**COUNCIL ASSESSMENT REPORT**  
SYDNEY EASTERN CITY PLANNING PANEL

<b>PANEL REFERENCE &amp; DA NUMBER</b>	PPSSEC-238 – DA-483/2022
<b>PROPOSAL</b>	Construction of three buildings ranging in height between 5 and 7 storey containing a mixed use industrial, warehouse and recreational development with 2 basement levels for parking, storage and plant areas (Water NSW & Integrated Development).
<b>ADDRESS</b>	Lot 2 DP 261143, Lot 1 DP 219847, Lot 3 DP 271143 2-6 Girawah Place, Matraville
<b>APPLICANT</b>	Mr Agy Dassakis, Spirecorp Pty Ltd
<b>OWNER</b>	Spirecorp Pty Ltd
<b>DA LODGEMENT DATE</b>	4 October 2022
<b>APPLICATION TYPE</b>	Development Application
<b>REGIONALLY SIGNIFICANT CRITERIA</b>	Clause 2, Schedule 6 of <i>State Environmental Planning Policy (Planning Systems) 2021</i> : Development that has a capital investment value of more than \$30 million.
<b>CIV</b>	\$37,802,636 (excluding GST)
<b>CLAUSE 4.6 REQUESTS</b>	None
<b>KEY SEPP/LEP</b>	Transport and Infrastructure SEPP, Biodiversity and Conservation SEPP, Resilience and Hazards SEPP Randwick LEP

<ul style="list-style-type: none"> <li>• Traffic and Parking Impact Assessment</li> <li>• Noise Impact Assessment</li> <li>• Plan

**Figure 14:** Lot 1 – Level 3 Floor Plan identifying the child care centre outlined in orange (Drawing No. DA-105)

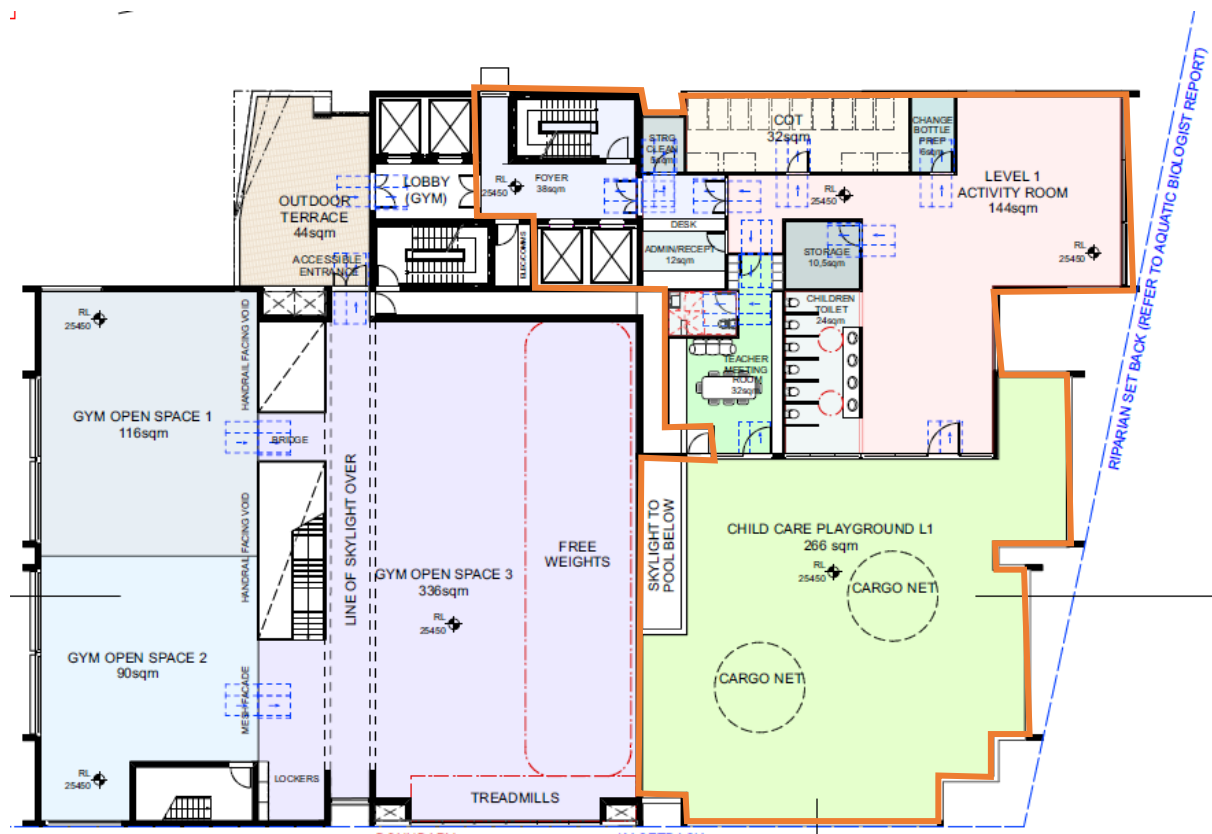
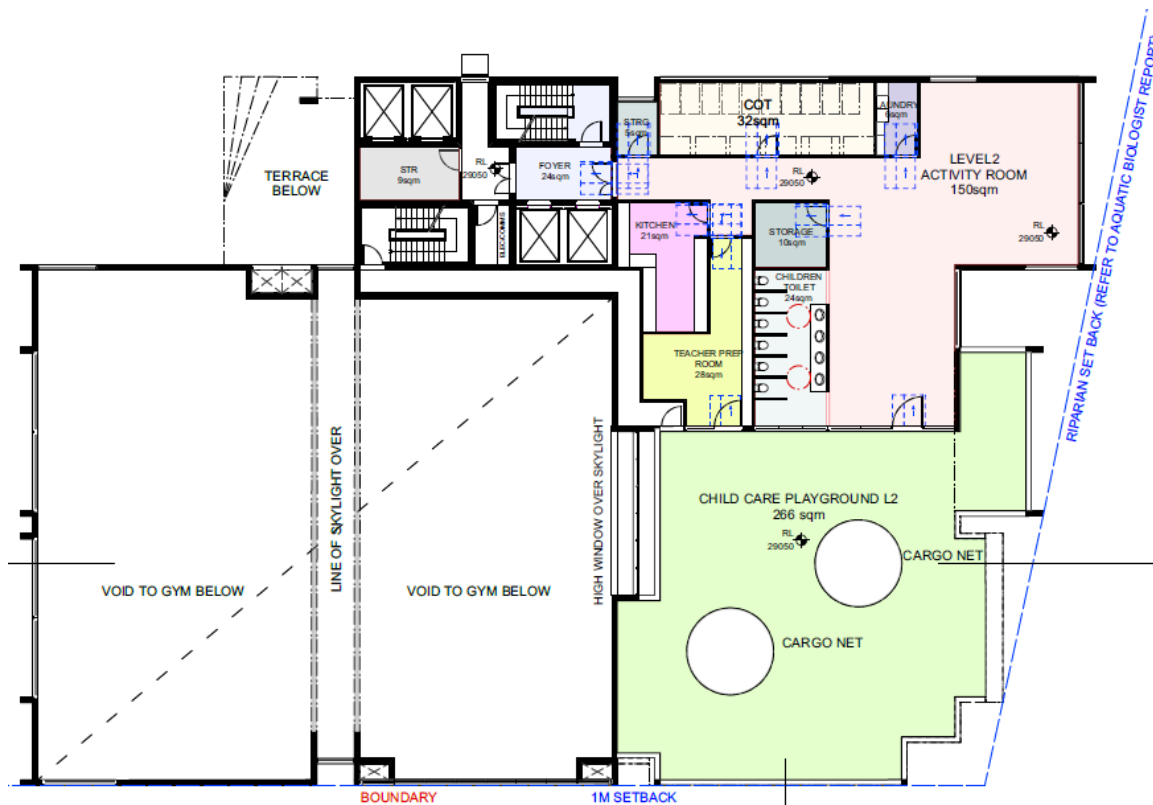
The 80 children will require a total unencumbered indoor play area of 260m<sup>2</sup>. The two spaces identified on the plans 294m<sup>2</sup> and would comply as a whole, though the number of children per floor is not specified in the application to confirm each play area is suited for the intended number of children. The age ratios do not allow for optimal halving of the children (e.g. 40 per floor) due to the staff ratios.

Notwithstanding the above, the applicant's specified indoor play areas have included the corridor and area between the reception desk, cot room and teacher meeting room on Level 3 as unencumbered indoor play area. The Child Care Planning Guideline states unencumbered indoor space excludes passageways or thoroughfares (including door swings) used for circulation. It is unclear how this space would actively be used as indoor play area, given its corridor design and the poor supervision from the main open area of the play area.

The plans have not adequately demonstrated the fit-out of the indoor play areas as no fixtures have been identified for storage, craft benches and sinks, temporary waste storage and the like. These elements will be encumbered space and further reduce the specified indoor area.

On both Level 3 and Level 4, the door swing areas leading to the outdoor play areas have been included and must be excluded.

**Figure 16:** Extract of the sun-eye diagram illustrating the voids of the child care centre outdoor play area on Level 4 and enclosed Level 3 outdoor play area (Drawing No. 160)

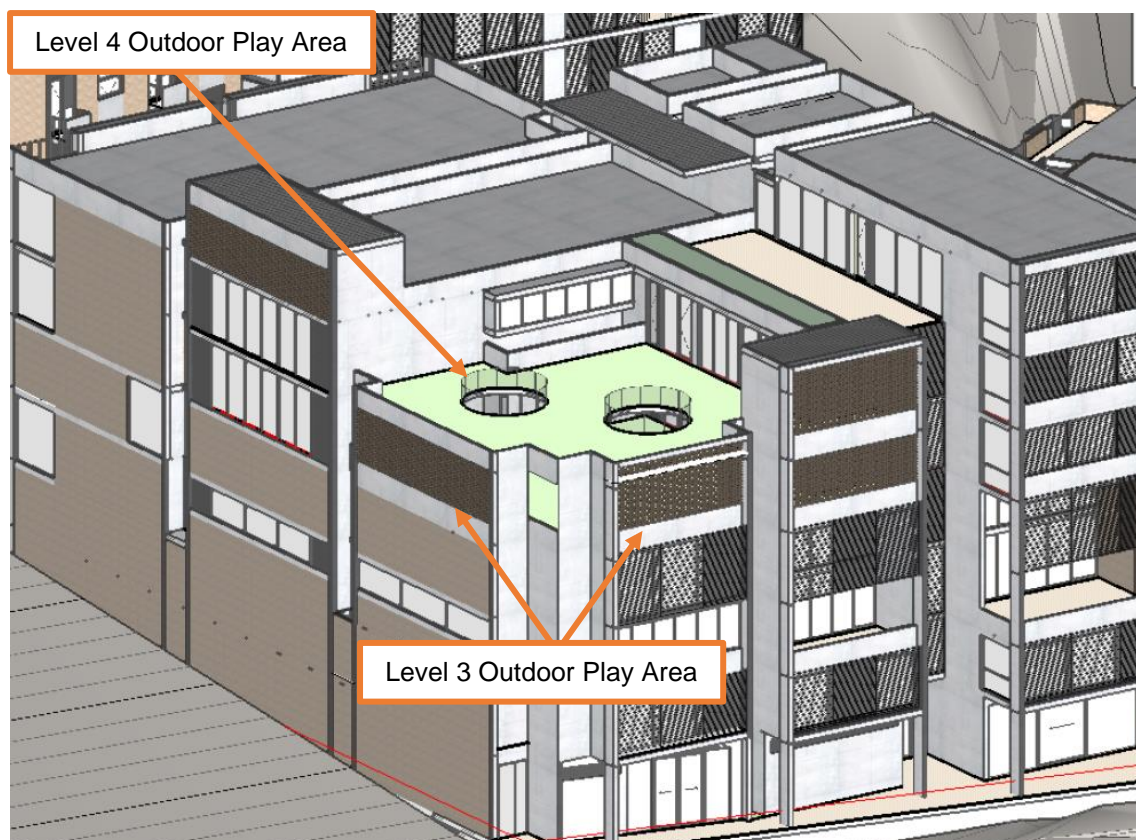
For the outdoor play areas, the identified 80 children will require 560m<sup>2</sup> of outdoor play area. The plans identify 266m<sup>2</sup> of outdoor play area on both levels, which is only 532m<sup>2</sup> and well short of the minimum requirement. Additionally, the Level 4 outdoor play area has been measured identically to the Level 3 play area, but Level 4 includes three voids to allow natural light and ventilation to the fully roofed and largely enclosed outdoor play area on Level 3 (see Figure 14). The voids are encumbered space and must be excluded, further increasing the non-compliance with the minimum outdoor play area.

Given the general absence of a fit-out and proposed distribution of children per floor within the centre, it cannot be determined whether the development has achieved the minimum indoor play area. The outdoor play area is non-compliant regardless.

**Figure 19:** Ground Floor Plan of Building 3 (Drawing No. DA 102)

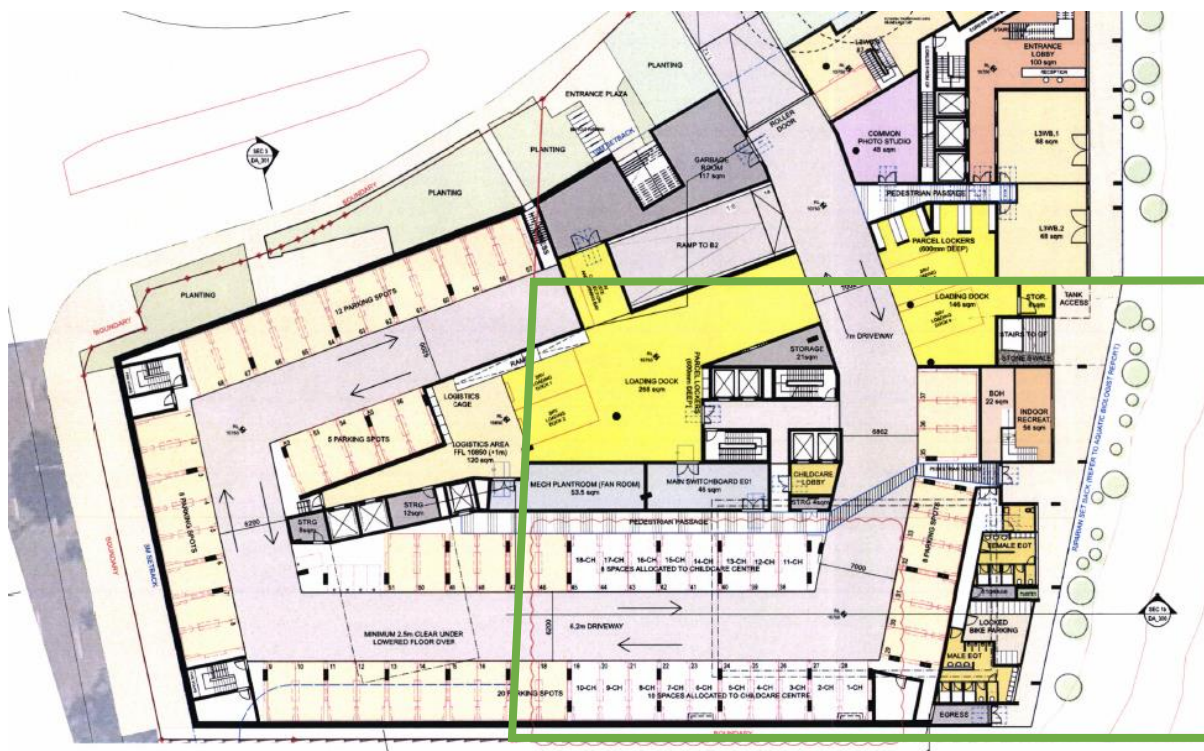
Although the abovementioned uses are permissible on IN1 General Industrial zoned land, the design of the development and the uses on the IN1 land depend on the land zoned RE1 Public Recreation to enable their operation. This is illustrated on the Basement Level 1 Plan. Refer to the below.

The documentation inconsistently refers to the purpose of the units. The SEE and traffic report refer to these units as high technology uses (light industrial). The architectural plans identify warehouses (e.g. the showroom text notes) while the traffic report in part refers to them as warehouse or distribution centres. While both uses are permissible, the characterisation affects the car parking rates, loading and the operational details.
